**6628A-11**

**S E R V I C E N O T E**

**6628A DC Power Supply**

**Intermittent Power Transformer “Magma” Connections**

**Top View of Power Transformer:**

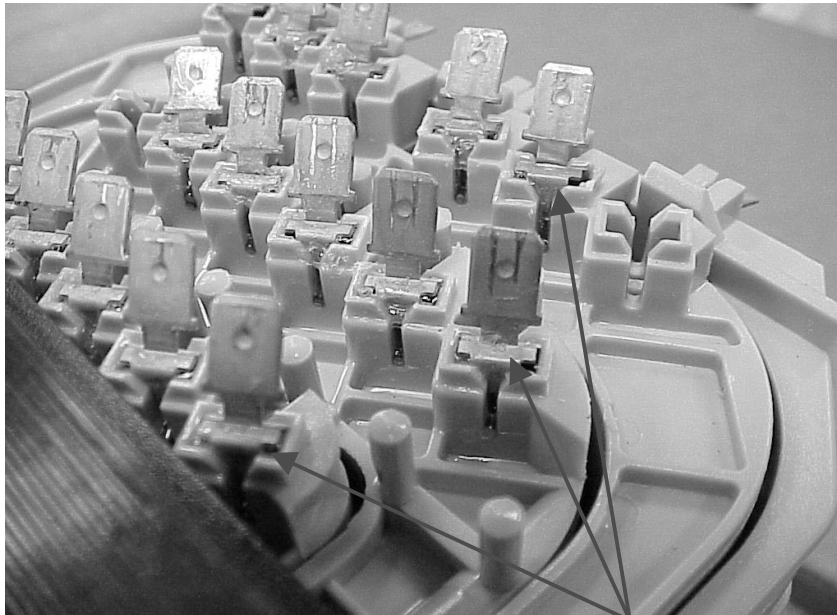
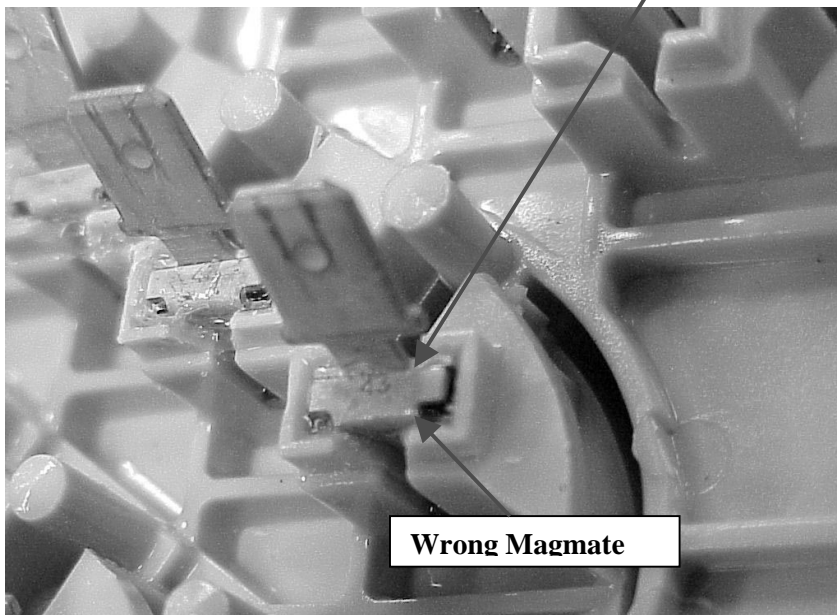
The power transformer vendor mistakenly installed the wrong “Magmates” in a run of power transformers. The incorrect “Magmates” have a # 43 stamped on them, which corresponds to a 15 gauge wire size. The correct size “Magmate” should be # 24 designed for a 19 gauge wire size.

**Incorrect “Magmate” number 43 on the Surface, This should be number**

**Wrong Magmate**

Replace the Power Transformer with a new replacement Transformer, see the table above for the correct power transformer part number.

**NOTE:** Please inspect the new transformer for the correct “Magmate” number stamping.
